Wolf Creek Dam (Lake Rene).
NDI I.D. Number PA-748. DER I.D.
Number 17-108. Ohio River Basin,
Wolf Creek, Clearfield County,
Pennsylvania. Phase I Inspection Report.

PHASE I REPORT
NATIONAL DAM INSPECTION PROGRAM

NAME OF DAM: Wolf Creek Dam
STATE LOCATED: Pennsylvania
COUNTY LOCATED: Clearfield
STREAM: Wolf Run, a secondary tributary of Sandy Lick Creek
DATE OF INSPECTION: April 4 and May 4, 1979

PLATE 7
 WOLF CREEK DAM
 GENERAL PLAN
 FIELD INSPECTION NOTES
 FIELD INSPECTION DATE: APR. 4, 79

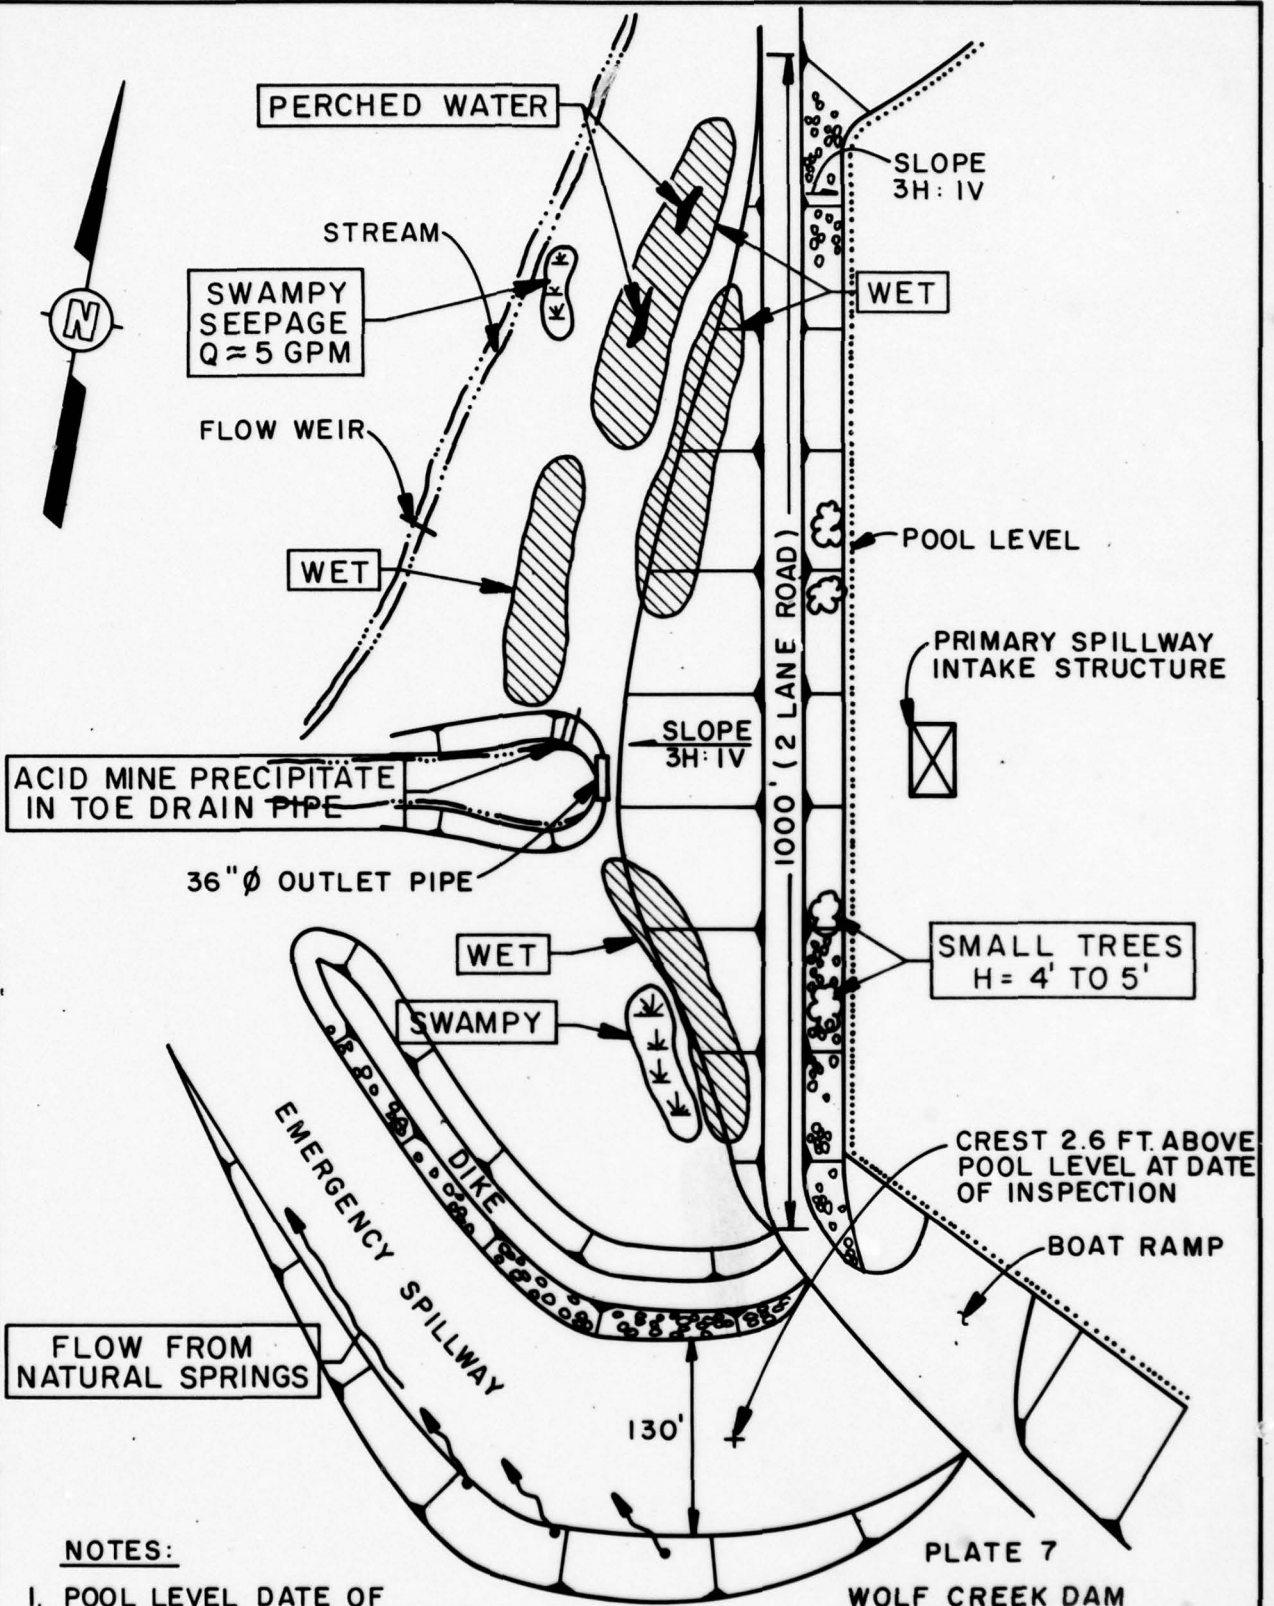
In general, the condition of the dam is considered to be good. However, numerous wet areas were found along the downstream slope and toe areas of the dam. Except for one seepage point located near the right abutment, no measurable seepage was found to be associated with these wet areas. In their present extent and condition, these wet areas are not considered to be a threat to the overall stability of the embankment at this time. However, periodic inspection would be required to insure that the conditions are not changing.

1. POOL LEVEL DATE OF INSPECTION 0.2 FT. ABOVE PRIMARY SPILLWAY CREST
2. EMERGENCY SPILLWAY FREEBOARD = 7.6 FT.

1. The wet areas located along the downstream face and the toe of the embankment should be periodically observed. Necessary remedial work should be performed if the extent of the wet areas increases or seepage and sloughing conditions develop.
2. Around-the-clock surveillance should be provided during unusually heavy runoff and a formal warning system should be developed to alert the downstream residents in the event of emergencies.
3. Small trees on the upstream face of the dam should be removed.
4. The dam and appurtenant structures should be inspected regularly and necessary maintenance should be performed.

PLATE 8

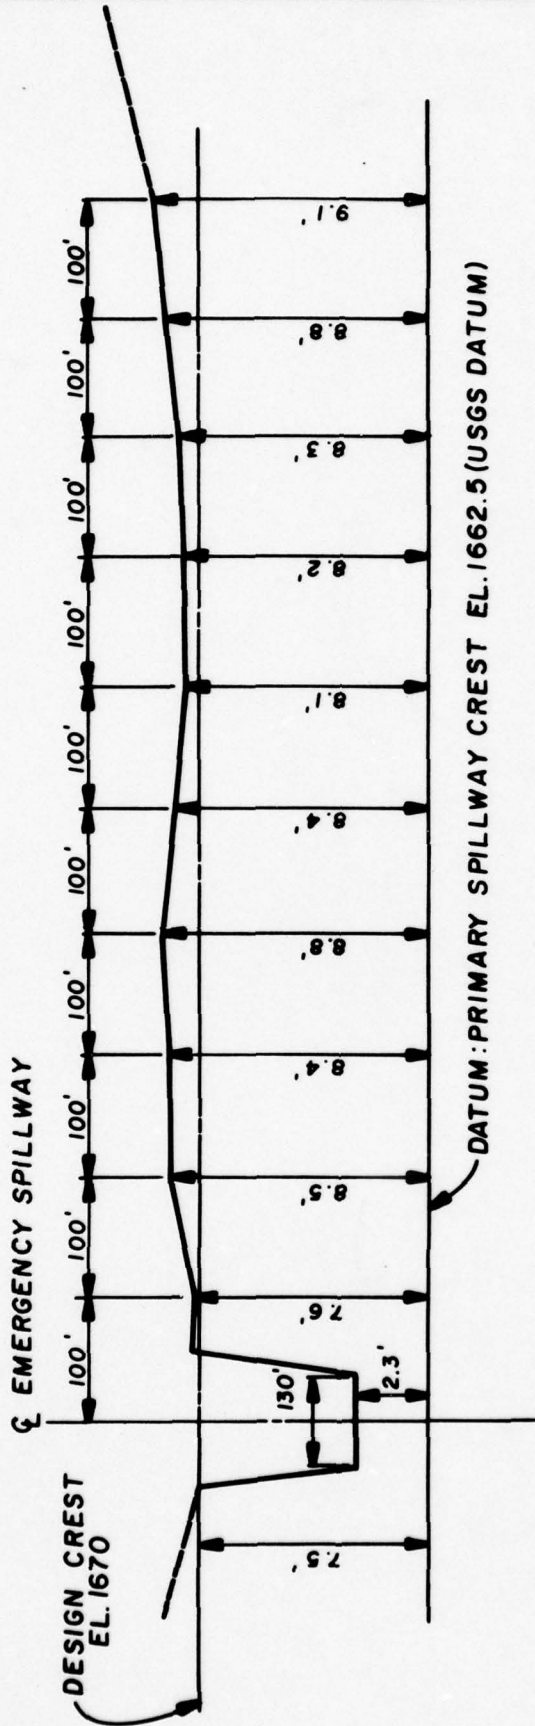
The top of the embankment was surveyed relative to the pool level on the date of inspection, which was estimated to be at Elevation 1662.6, the spillway crest level (Elevation 1664.5), and the crest of the embankment was found to be approximately 0.7 to 1.0 foot above the design elevation of 1670. The dam crest profile is illustrated on Plate 8.
